PLANNING APPLICATION - PLA/2024/34
Construction of a general retail building and buildings for visitor accommodation
ASSESSMENT REPORT

The purpose of this report is for Council to determine a planning application submitted by Lynden Jones Architect for the construction of a general retail building, and buildings for visitor accommodation with access via Christopher Street located at 65 Main Street Derby. Pursuant to the Town Centre Parking Specific Area Plan general overlay, car parking provision for the purposes of the proposed retail building is not required. Parking spaces for the visitor accommodation component of the proposal however is required; and these spaces are proposed to be provided in proximity to the eastern boundary of the property. These spaces would be accessed via a shared right of carriageway network extending from the sealed portion of Christopher Street and across multiple parcels of public (council-owned) tenure identified below and further on in this report as Christopher Street.

Figure 2: An excerpt of the submitted site plan.

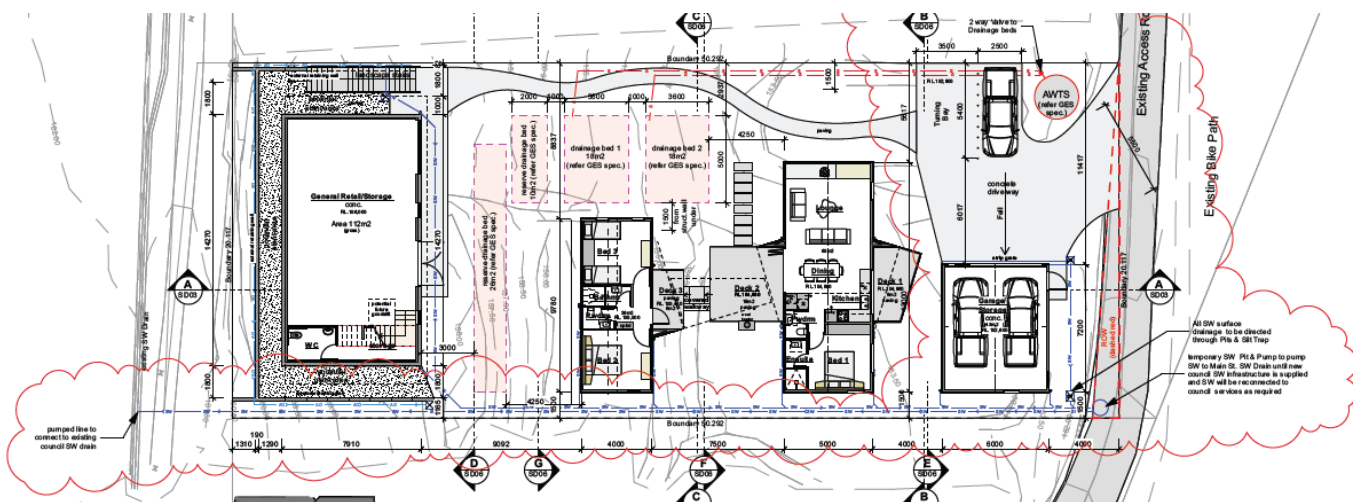
The application seeks planning approval for the development of one retail building, and three buildings for visitor accommodation use (2 habitable buildings connected by roofed decking/walkway) and one separate garage (refer to Figure 2 for a visual representation). Works associated with this proposal include:

Figure 3: An excerpt of the submitted retail building's Main Street elevation, as viewed from the public footpath, with finishes detail.

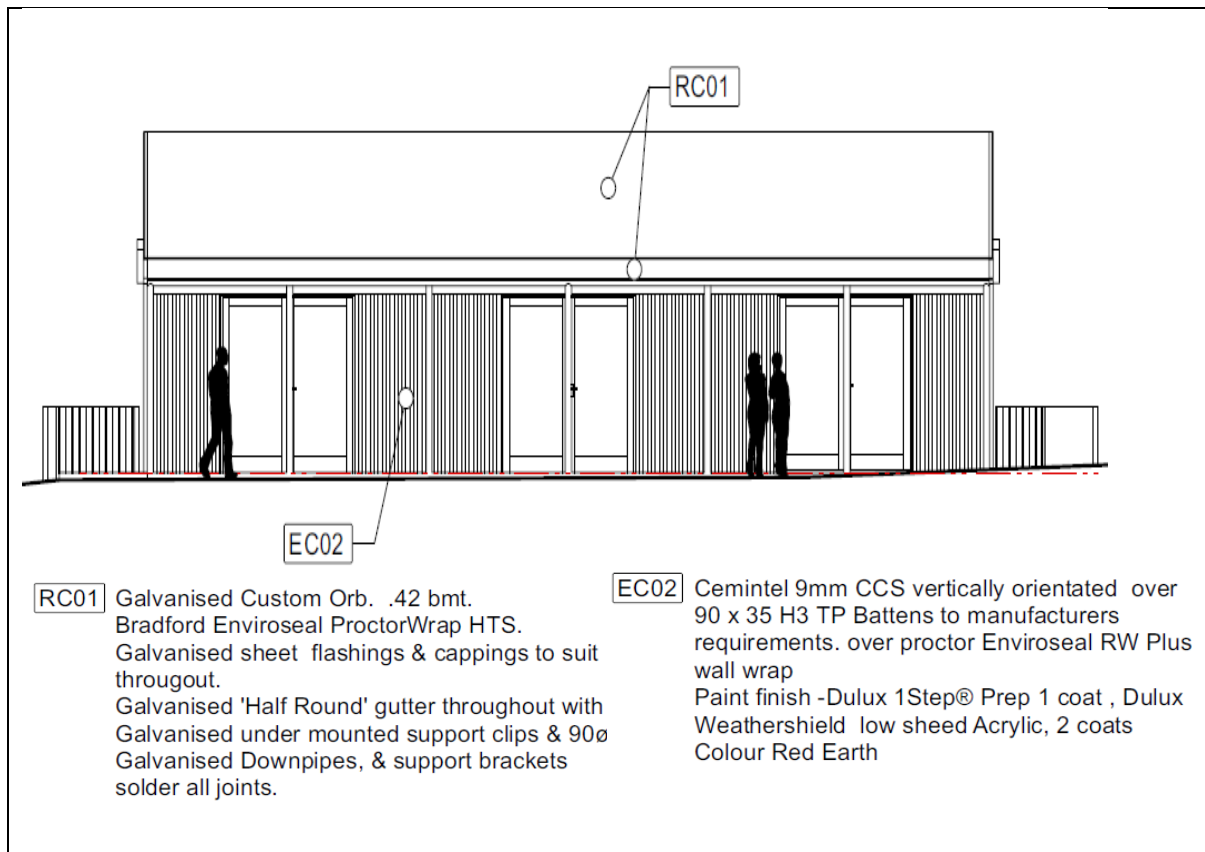
The proposed finish of the building as viewed from Main Street would be galvanised corrugated sheet roofing and vertically arranged cladding on the exterior front wall painted in the colour Dulux Red Earth (see Figure 3). The side walls would be vertically arranged corrugated cladding.

Figure 4: Aerial perspective showing locations of 59 Main Street and 69 Main Street.

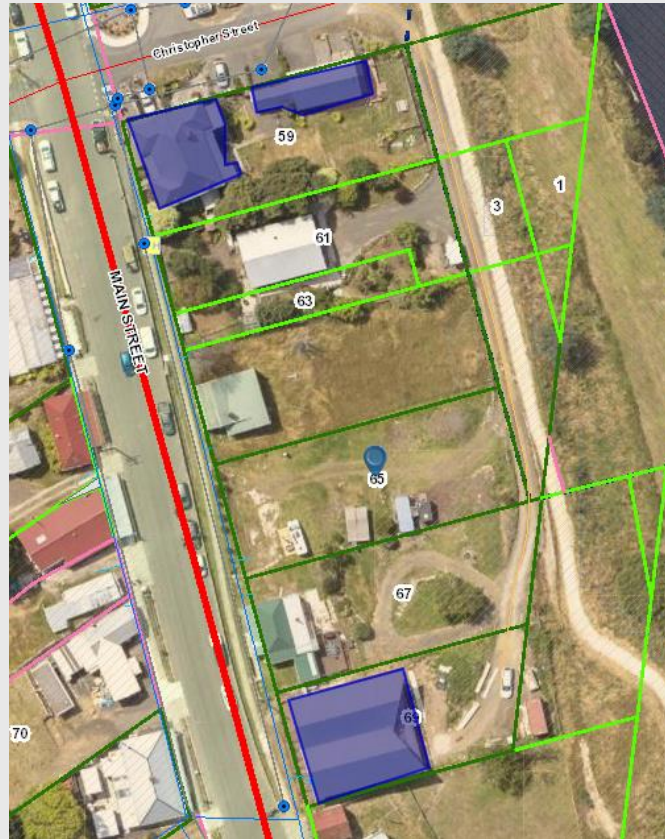
The site coverage of the proposed development is comparable to sites along Main Street. Examples include 59 Main Street with a site coverage of approx. 33% and 69 Main Street has a site coverage of approx. 44% (refer to Figure 4 for location). Both examples have permits for a mixed-use of accommodation and retail.

<p>The setbacks of surrounding buildings:</p>	<p>The setbacks are similar to the surrounding buildings, some of which are aligned with side boundaries as in the cases of 67, 61 and 59 Main Street (visual reference can be seen in Figure 4. On the opposite side of Main Street to the subject site, there is very little space between the boundaries of lots and the buildings as is the standard with older buildings used on a commercial basis along Main Street.</p>
<p>The height, bulk and form of existing and proposed buildings:</p>	<p>The site is vacant and the design of the proposed buildings presents a staggered visual form down the slope, with the shortest ends facing adjoining properties, this decreases the visual appearance of bulk of the structures.</p> <p>The accommodation sections of buildings do not present blank right-angled forms of large scale, and the heights and are a few metres less than the acceptable solution for maximum height for structures within the Village Zone.</p> <p>The retail building presents more of a bulky visual presence than the accommodation buildings, however, it is proposed to be set into the ground to decrease its visual impact, and the height complies with the acceptable solution of clause 12.4.2.</p> <p>For context to what could be permitted development (but that would create greater impact in terms of height, bulk, form and the consequential overshadowing effect on southern adjoining properties). The proposal could be of a standard cubic form single dwelling, with the acceptable solution setback of 3 metres, and a sharp pitched roof that projected upwards to the acceptable 8.5 metres, the impact would be far greater and theoretically not require a planning permit were all other acceptable solution provision of the Scheme complied with.</p> <p>In light that the proposal is designed in a manner that is sympathetic to its spatial context, more so than the acceptable solutions of the village zone, the impact is negligible.</p>

Figure 6: Extract from the proposals sun study diagrams – Winter solstice

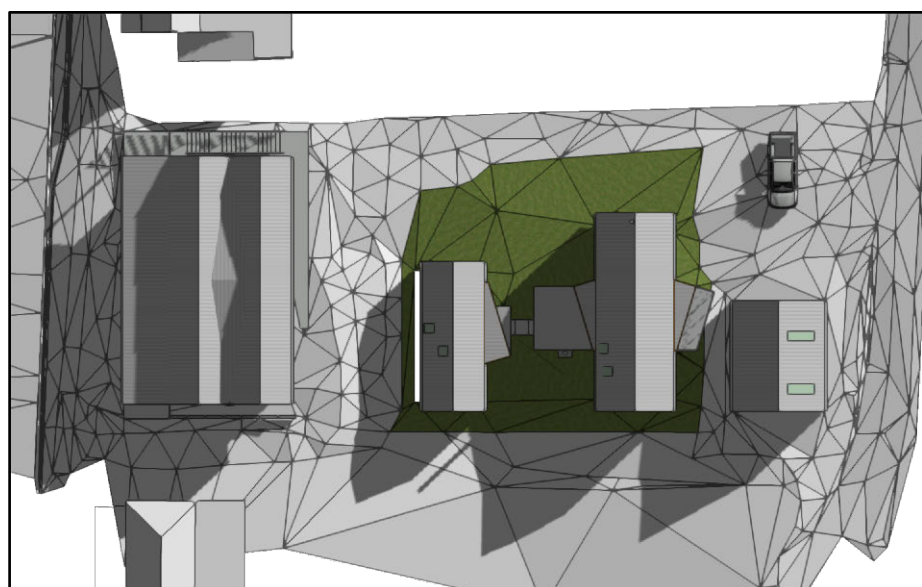
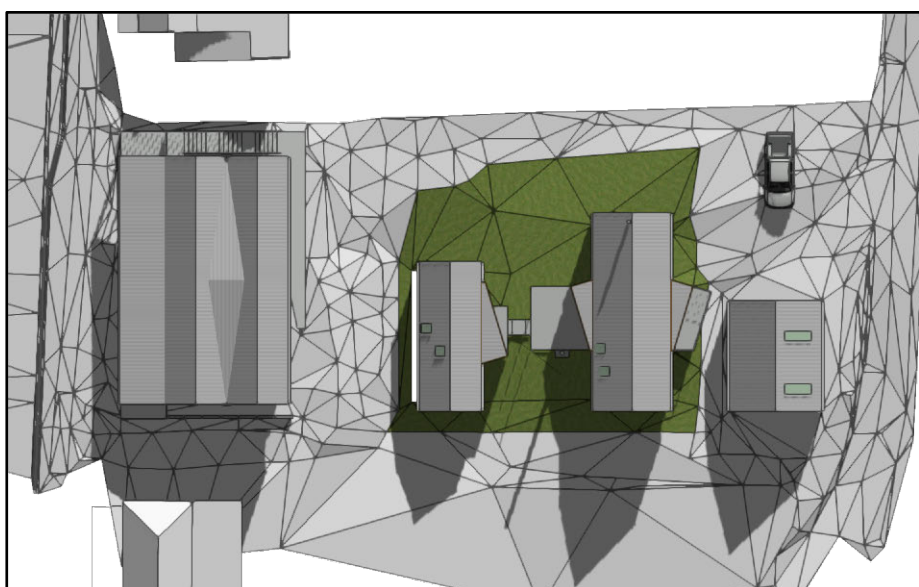
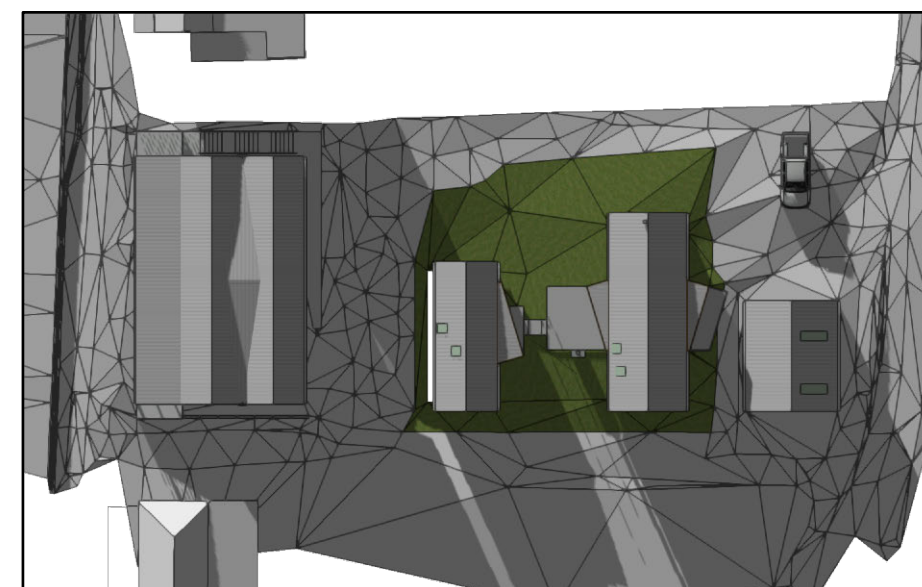
There would be some reduction in the direct sunlight to the habitable rooms (the northern-facing bedrooms) of 67 Main Street, created by shadows caused by the retail building however, the proposal would not block all light from the rooms. The submitted shadow diagrams (refer to Figure 6) illustrate that the greatest impact on these rooms would be during the Winter solstice, where both rooms would be subject to some shadow for approximately 3 hours around midday.
